Catherine Riiska December 10, 2019 Page 11 of 17

K. Determination of compliance with transportation requirements

THE RESERVE AT JENSEN BEACH MARTIN COUNTY, FLORIDA

CERTIFICATE OF OCCUPANCY PHASING PLAN

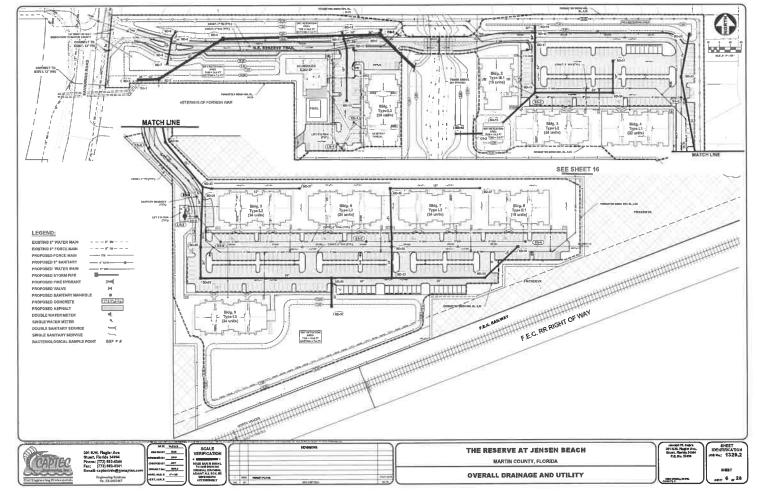
1. The current notes associated with the phasing plan appear to describe the sequence of construction within each phase. All references to sequencing or scheduling shall be removed. Instead, the requirements for the Core Infrastructure and Certificate of Occupancy shall be listed for each phase. See Pennock Preserve PUD phasing plan as an example.

2. The sub-phasing of required design elements on a building by building basis will not be permitted. Revise the phasing boundaries to be consistent between the Earthwork, Drainage, Utility, Paving, and Landscaping plans.

Please refer to the enclosed revised CO Phasing Plan (see Sheet 4 of 28), which has been revised per our meetings with staff. The detail is provided to ensure all required items are constructed for each Certificate of Occupancy requested, as previously requested by the Development Review Administrator.

Acknowledged, please refer to the enclosed revised CO Phasing Plan (see Sheet 4 of 28).

Acknowledged, please refer to the enclosed revised CO Phasing Plan (see Sheet 4 of 28).

R-60

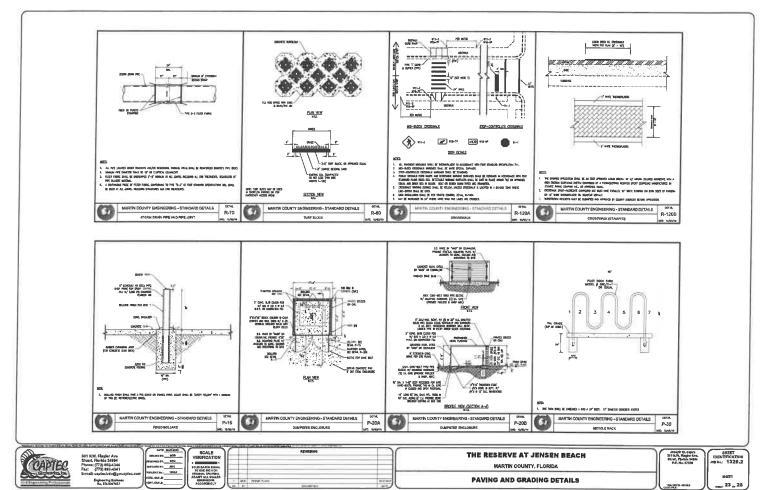
31. Include Martin County Standard Detail R-60 within the detail sheets.

Acknowledged, Martin County Standard Detail R-60 was added to Sheet 5.
